Comment #146, #174: Low-Frequency CTLE to support 3m cable w/o FEC

Yasuo Hidaka
Fujitsu Laboratories of America, Inc.

September 16-18, 2015

Comment #146 and #174

Test 1 Result (DER0=1E-12) for 3m Cable

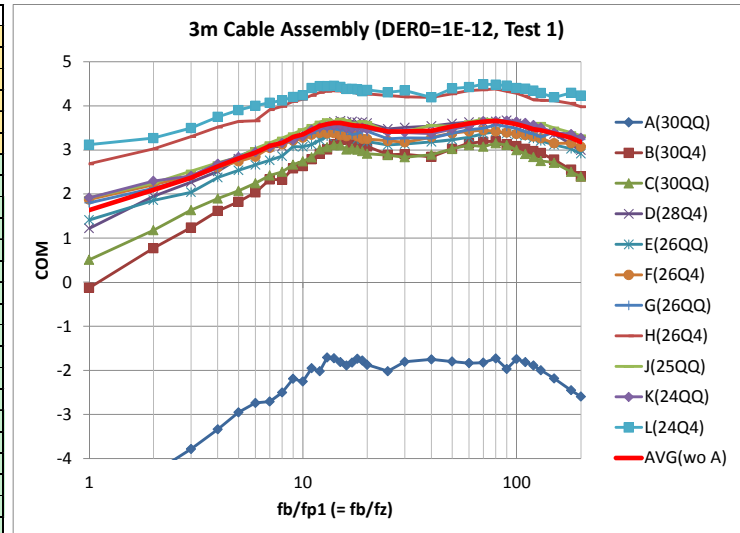
- With fp1=fb/4, 2 out of 11 exceed 3dB.
- With fp1=fb/15 or fb/60, 10 out of 11 exceed 3dB.
 - Improvement from fb/4 is 0.7~1.6dB (average 1.0dB).
 - Anyway, A is not acceptable.

Test 2 Result (DER0=1E-12) for 3m Cable

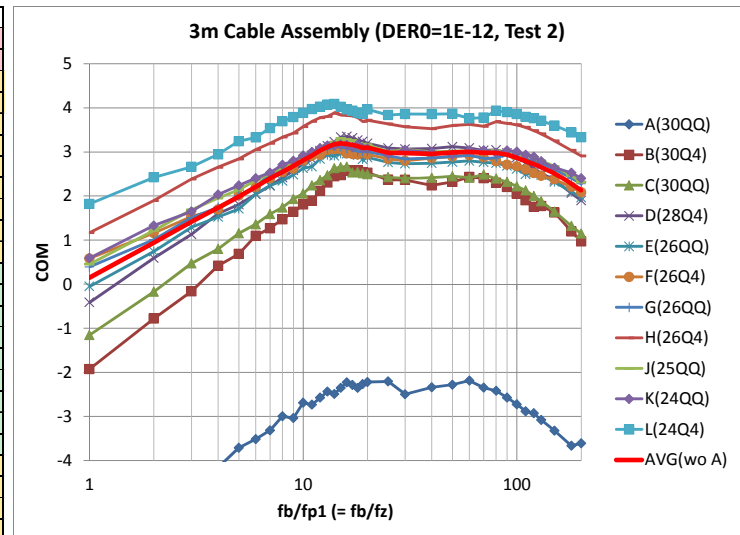
- With $fp1=fb/4$, none exceeds 3dB.
- With $fp1=fb/15$, 7 out of 11 exceed 3dB.
 - Improvement from $fb/4$ is 1.1~2.1dB (average 1.5dB)
- With $fp1=fb/60$, 5 out of 11 exceed 3dB.
 - Improvement from $fb/4$ is 0.8~2.0dB (average 1.3dB)

Test 1 Result (DER0=1E-12) for 5m Cable

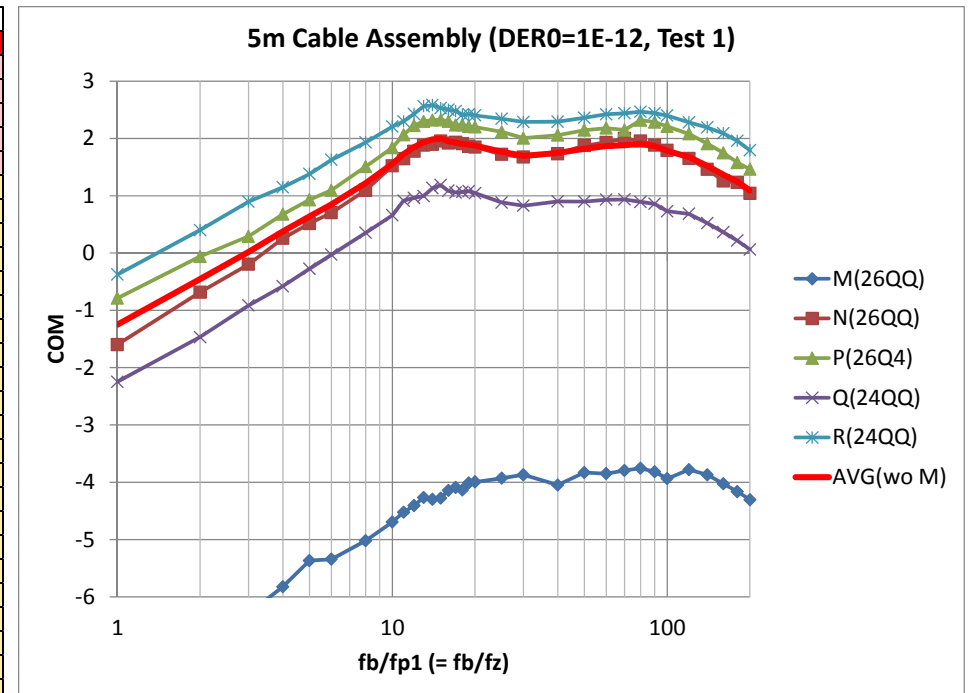
- None exceeds 3dB.
- With $fp1=fb/4$, 1 out of 5 exceeds 1dB.
- With $fp1=fb/15$, 4 out of 5 exceed 1dB.
- With $fp1=fb/60$, 3 out of 5 exceed 1dB.

Test 2 Result (DER0=1E-12) for 5m Cable

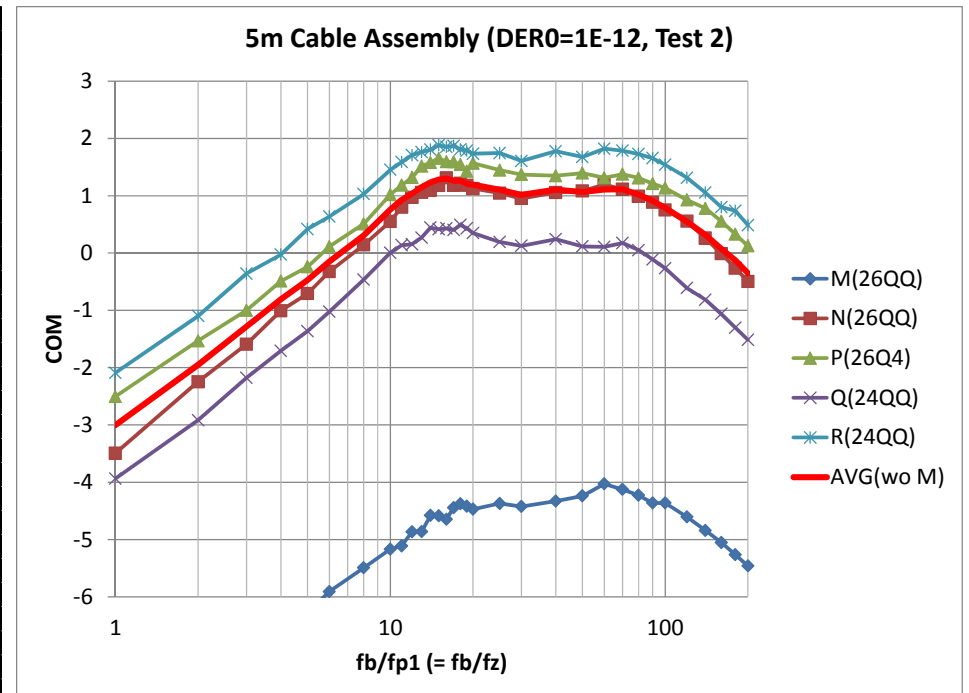
- With $fp1=fb/4$, none exceeds 1dB.
- With $fp1=fb/15$ or $fb/60$, 3 out of 5 exceed 1dB.
